DETAILED ACTION

Continued Examination Under 37 CFR 1.114

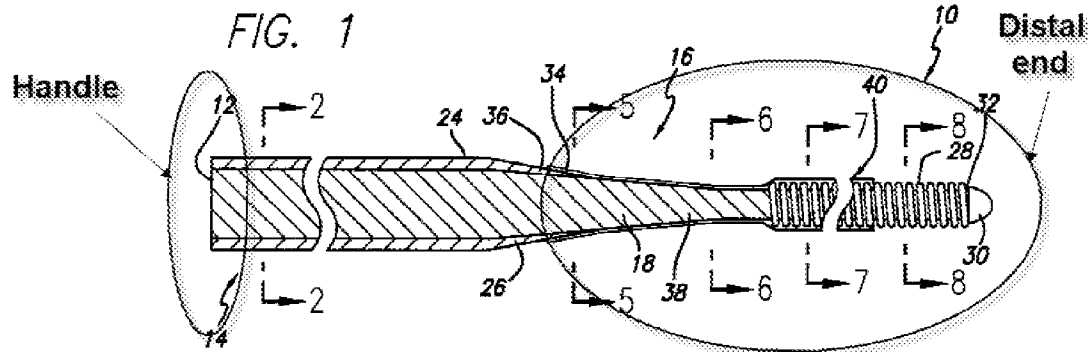
7. In regards to claim 1, Ferrera discloses a stylet having a proximal end and distal end comprising a handle disposed on the proximal end (please see figure above - the noted region is a "handle" because it is capable of being gripped and the "distal end" can be considered an arbitrary distal portion of the stylet); an outer covering that is a tube spanning from the handle to the distal end (24) made of metal (col. 3, lines 20-25) and having a solid annular lateral cross-section (Fig. 2); and a solid inner core (12)

surrounded by the outer covering from the handle to the distal end (see figure above) made of inner core material (col. 3, lines 1-5), wherein the outer and inner materials have different elastic and buckling properties (by virtue of the outer material being stainless steel and the inner material being Nitinol).

8. In regards to claim 5, the stylet is isodiametric between the handle and distal end (see figure above - the border of the "distal end" being considered the point where the outer sheath begins to taper).

9. In regards to claim 6, the inner core has a variable diameter along the length of the stylet (in the "distal end" - see figure above).

10. In regards to claim 7, the outer covering (24) has a substantially constant wall thickness from the handle to the distal end (see figure above - in this interpretation, "distal end" includes the tapered portion 26).

11. In regards to claim 8, the stylet has variable outer circumference along the length of the stylet from the handle to the distal end (see figure above - in this interpretation, "distal end" does not include tapered portion 26).

13. In regards to claim 10, the inner core (12) has a substantially constant thickness along the length of the stylet from the handle to the distal end (see figure above).

15. In regards to claim 22, the stylet comprises a distal and proximal end wherein the diameter of the inner core increases along the length of the stylet from the handle to the distal end of the stylet (see figure above - under this interpretation, the "distal end" and "handle" are on the opposite ends from those shown). Nothing in the claim language prohibits an arbitrary consideration of either end being "proximal" or "distal," such as a limitation drawn to the distal end being adapted for insertion into a lead, while the proximal end remains external to the lead. Further, there is no requirement that the "handle" cannot be capable of insertion into the lead, such as a requirement that the handle be of a larger diameter than the rest of the stylet.
